P-12982

S3836

**JINDAL ALUMINIUM LTD.**  
BANGALORE-560073 (INDIA)

PARTY'S NAME	HINDAUN SLATE PRODUCTS (I), KAROULI (RAJ.)
PARTY'S DRAWING No.	AS PER DRAWING
ALLOY & TEMPER	6063 T6
DESCRIPTION	DISPLAY SECTION

NAME	DATE
DRAWN	PARVESH	15-10-2013
CHECKED		
APPROVED	S.S.GARG	19-10-2013
SCALE		3:1
AREA mm <sup>2</sup>		80.433
PERIMETER mm.		147.909
WEIGHT kg/m		0.217
DRAWING No.	SECTION No.	
P-12982	-	
S3836	S3836 (ISSUE-2)	
35094	35094

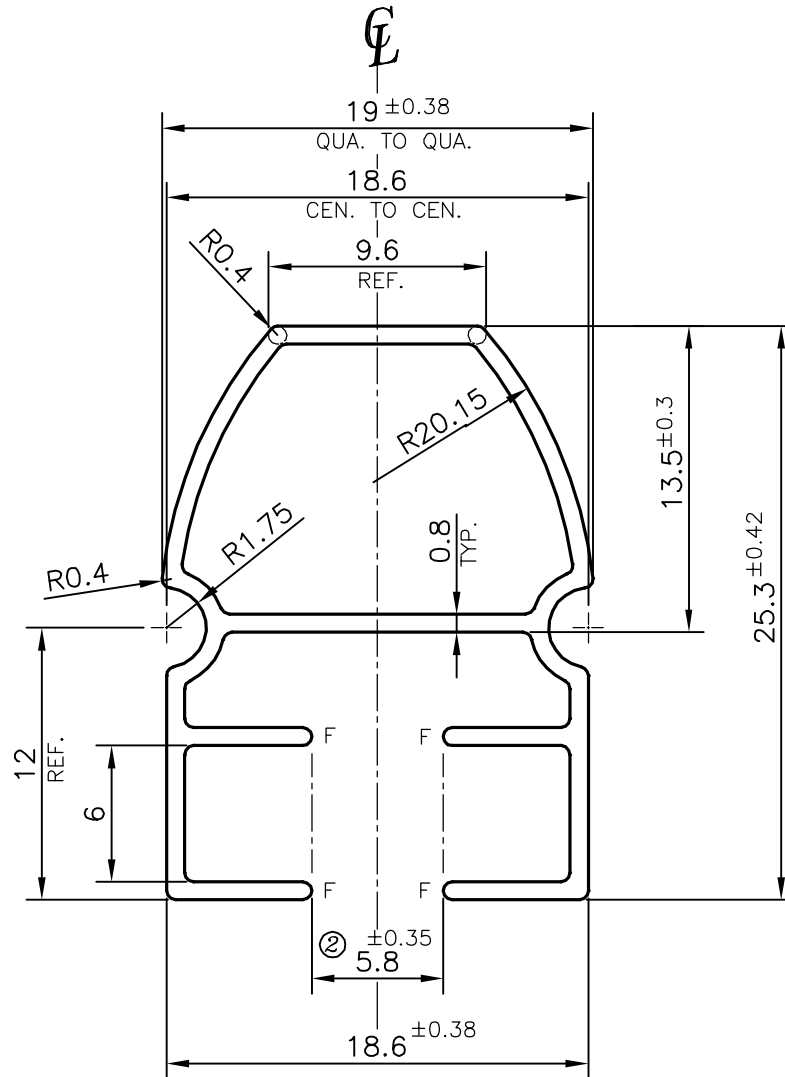
- ☞ DIMENSION CHANGED FROM 5.5 mm. TO 5.8 mm.
- ☞ WEIGHT ALSO CHANGED FROM 0.218 Kg/M TO 0.217 Kg/M
